Application for Variation of an Environmental Permit

Proposed Golf Course Development at Tai Po Lot No. 246 Shuen Wan

Environmental Review Report for Application of Variation of Environmental Permit
(VEP)

Reference: 289499-REP-042-03

Comparison of Operation Hours under Different Stages

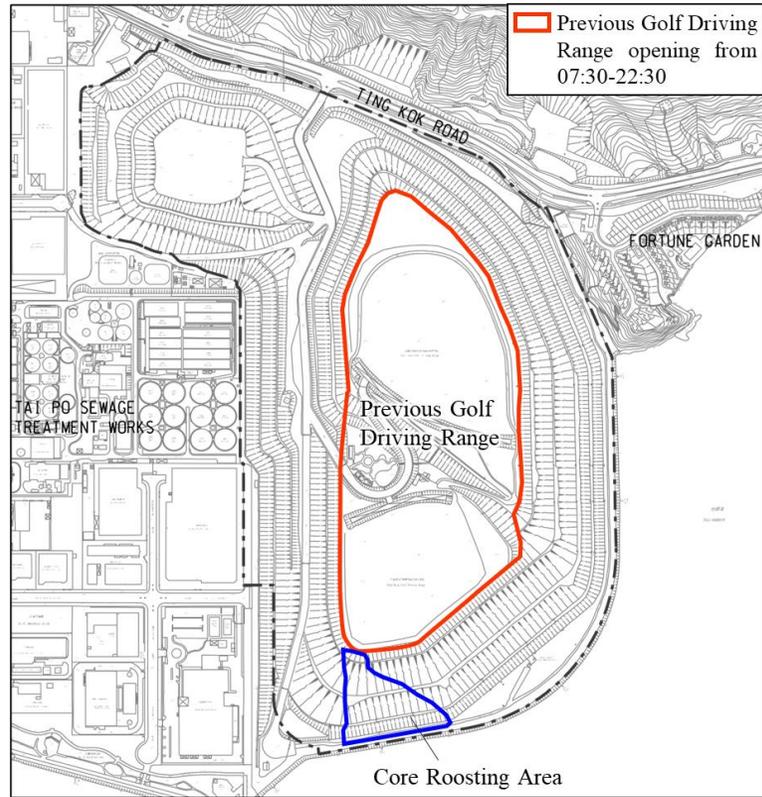
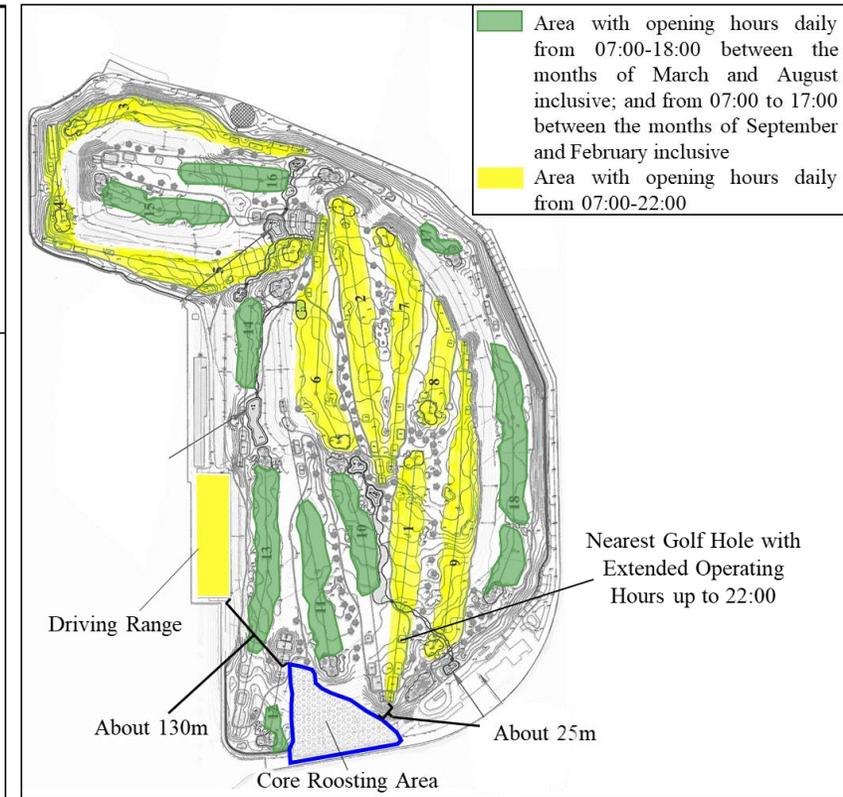
- 3.3.3.1 Under the latest design, as shown in Figure 3 of **Appendix 3.2**, the proposed driving range will be located at the western side of the Project Site, adjacent to the eastern boundary of the Tai Po Industrial Estate. To accommodate the busy schedules of working professionals and youth, the driving range and several golf holes within the outdoor playing area are proposed to operate during evening hours, up to 22:00. The remaining golf holes will adhere to the operating hours stipulated under Condition 2.43 and 2.44 of the FEP-01/571/2019/B.

- 3.3.3.2 As shown in Figure 3 of **Appendix 3.2**, the proposed driving range and the nearest golf hole with extended operating hours up to 22:00 are located approximately 130m and 25m respectively from the core roosting area. The separation distance is larger than that of both the previous golf driving range and the proposed driving range in the approved EIA Report, which were situated directly adjacent to the core roosting area. In addition, buffer planting will be provided between the proposed golf holes and the core roosting area to further minimise the potential ecological impacts.

- 3.3.3.3 In addition, as shown in Figure 3 of **Appendix 3.2**, the proposed golf hole (i.e. tentatively indicated as Hole 18) at the eastern edge of the Project Site will not operate with extended operation hours until 22:00, in order to minimise potential ecological impacts on the night roosting site for CC and BK, which were observed during the ecological survey in the approved EIA Report. According to the Tree Preservation, Transplantation and Compensation Plan (TPTCP) under Condition 2.14 of the FEP-01/571/2019/B, preservation of tree groups and compensatory planting are recommended for implementation along the eastern edge of the Project Site.
